DATE: July 16, 2021
TO: All Bidders
FROM: Jo Nell Miller, Purchasing Specialist
SUBJECT: Addendum 2 – Bid 622 Moorpark College Softball Backstop and Fencing Project

Replace Drawing A103 and A501 as attached and refer to Drinking Fountain and Filter Cut sheets attached.

**MOORPARK COLLEGE SOFTBALL FIELD
NEW BACKSTOP AND FENCING**

A103

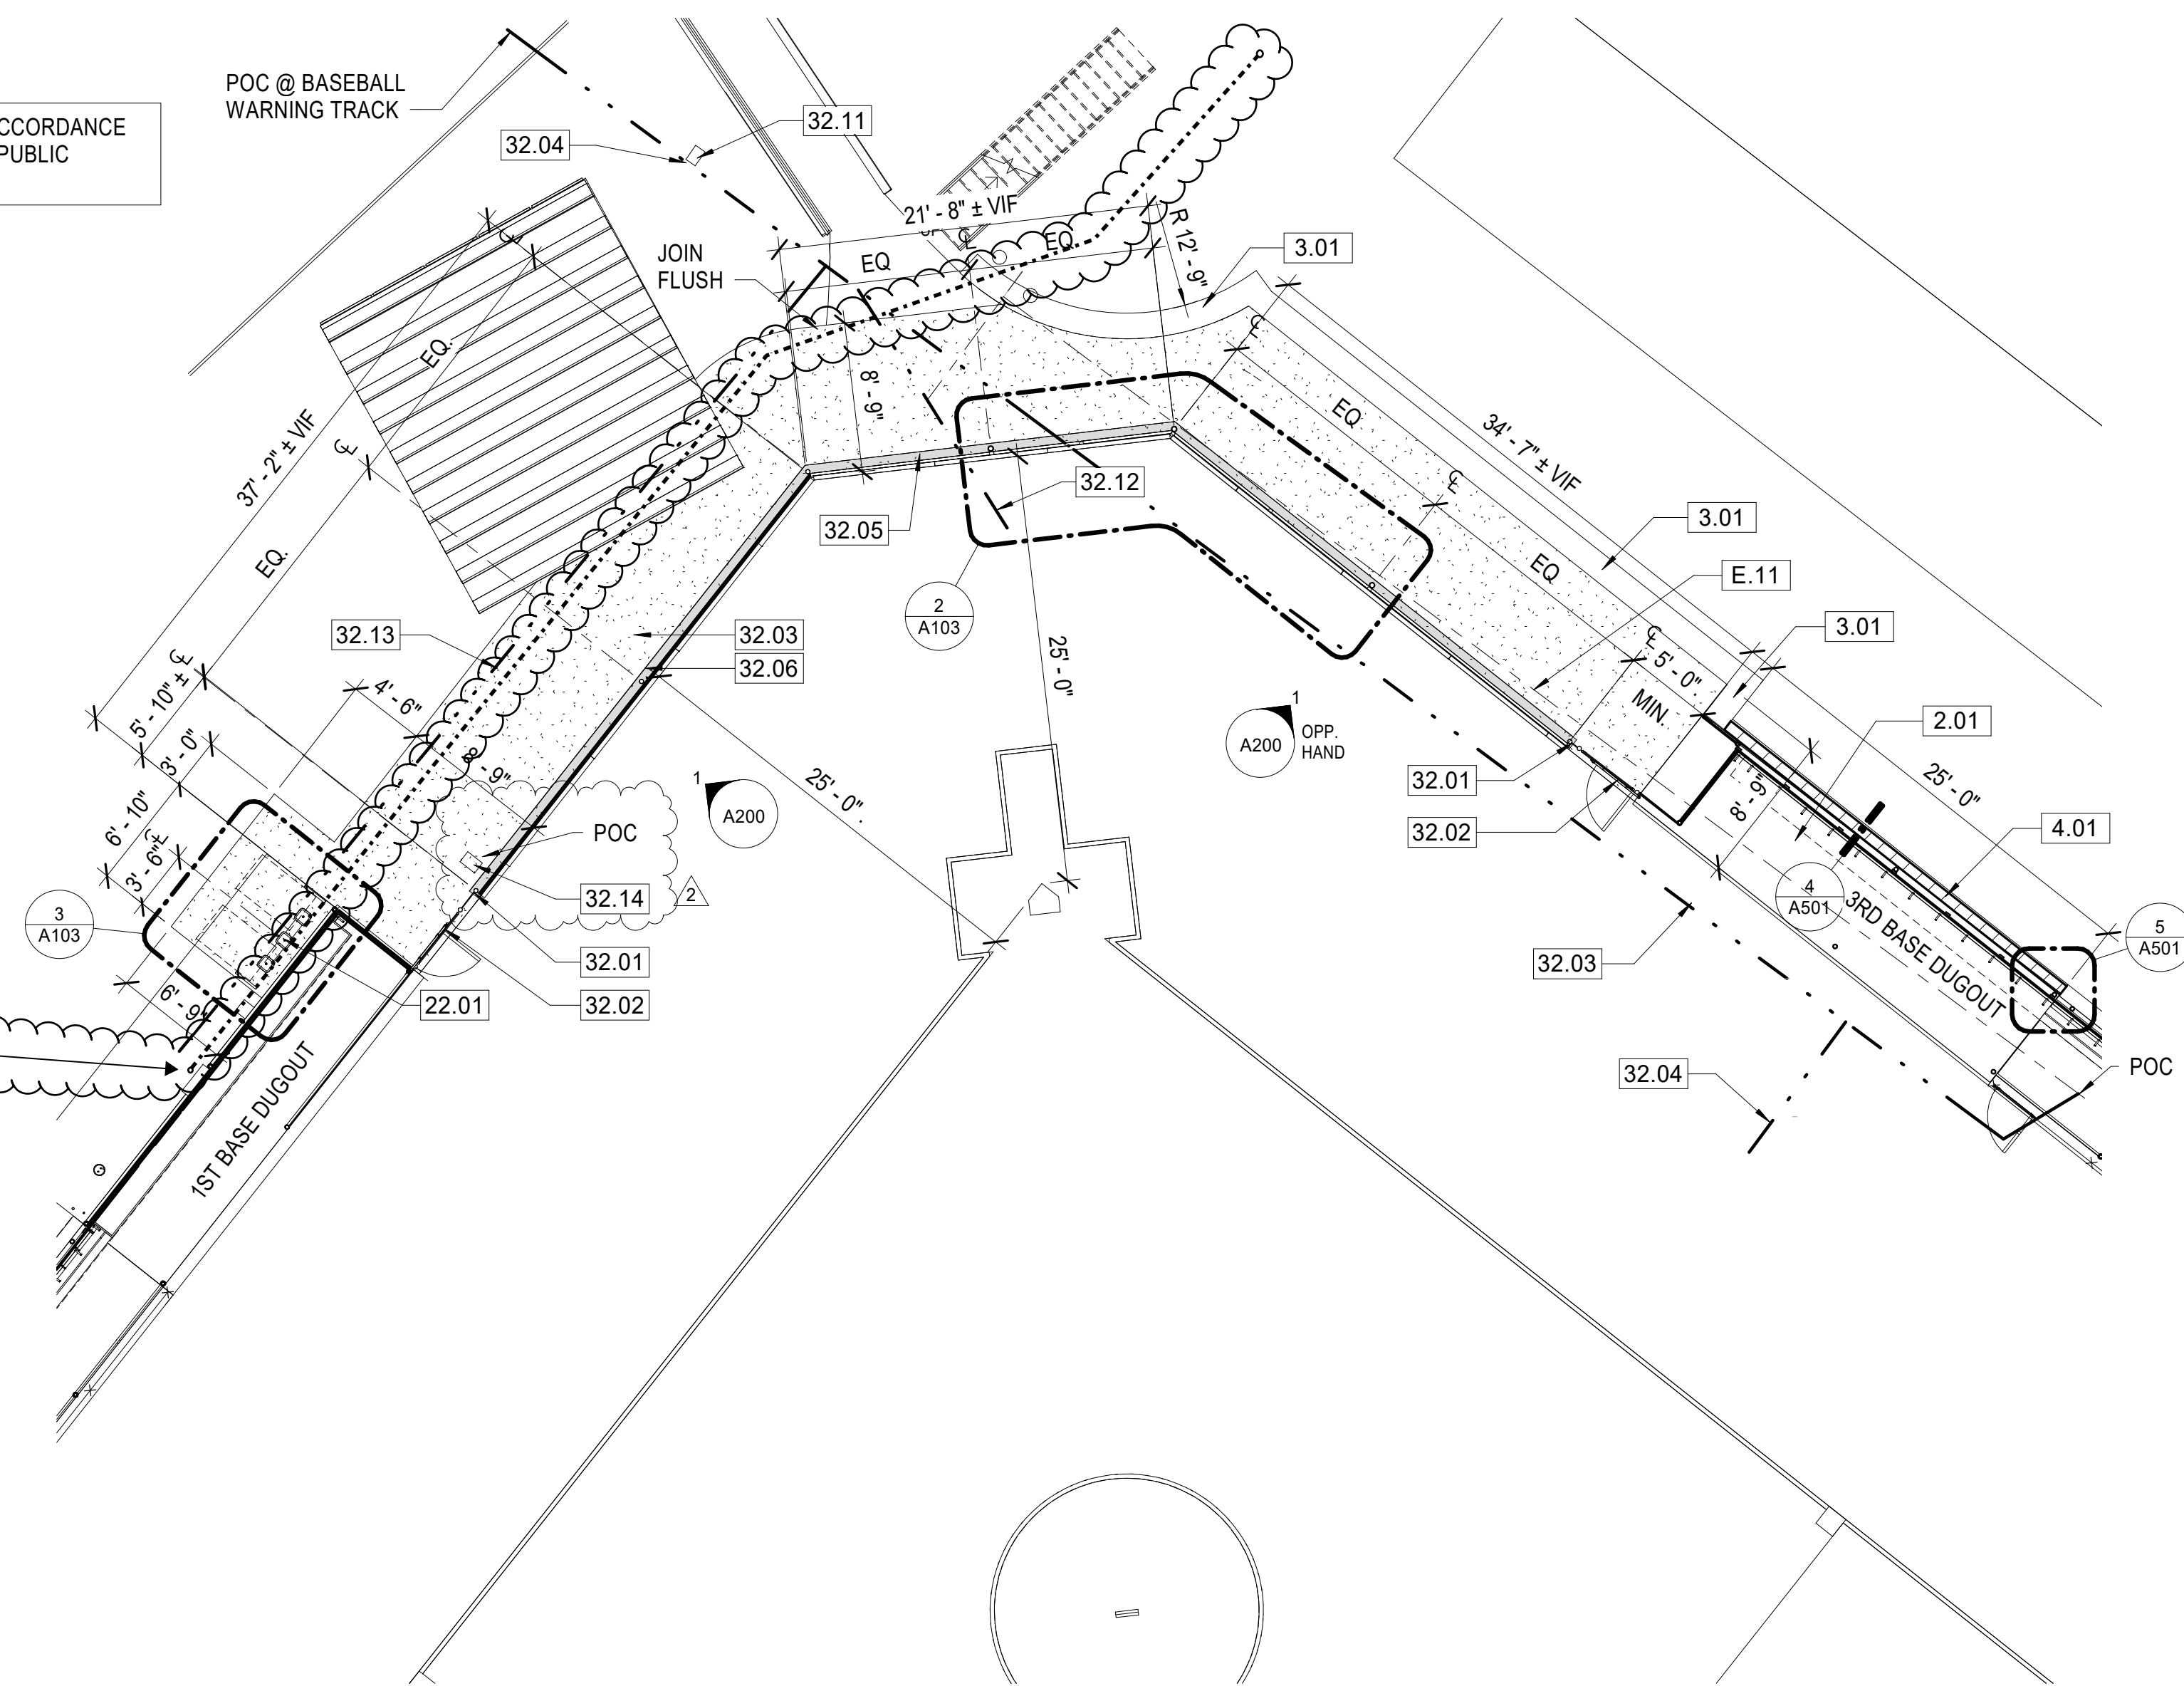
1. Provide ¾" cold water supply line and shut off valve from existing Water Point of Connection as shown on Drawing A103.
2. Provide drywell and 1" drain line to Drinking Fountain as shown on Drawings A103 and A501.
3. Provide two 1" PVC conduits underground from below existing electrical panel at First Base Dugout to location on Drawing 103.

- 32.11 RELOCATE (E) VALVE AND QUICK COUPLER. LEAVE 2" PVC STUB FOR FUTURE
- 32.12 ADD (6) 2" PVC SLEEVES UNDER WALKWAY AND BACK STOP INTO INFIELD
- 32.13 PROVIDE (1) 2" PVC SLEEVE UNDER CONC. WALKWAY

- 32.14 PROVIDE YARD BOX @ POINT OF CONNECTION FOR 3/4" COPPER WATER LINE FOR DRINKING FOUNTAIN
- E.11 (E) 4" ACP

DRINKING FOUNTAIN: DRINKING FOUNTAIN SHALL BE HAWS MODEL 3612 WITH MODEL 6425 IN LINE FILTER OR EQUAL. PROVIDE OWNER WITH THREE ADDITIONAL FILTERS
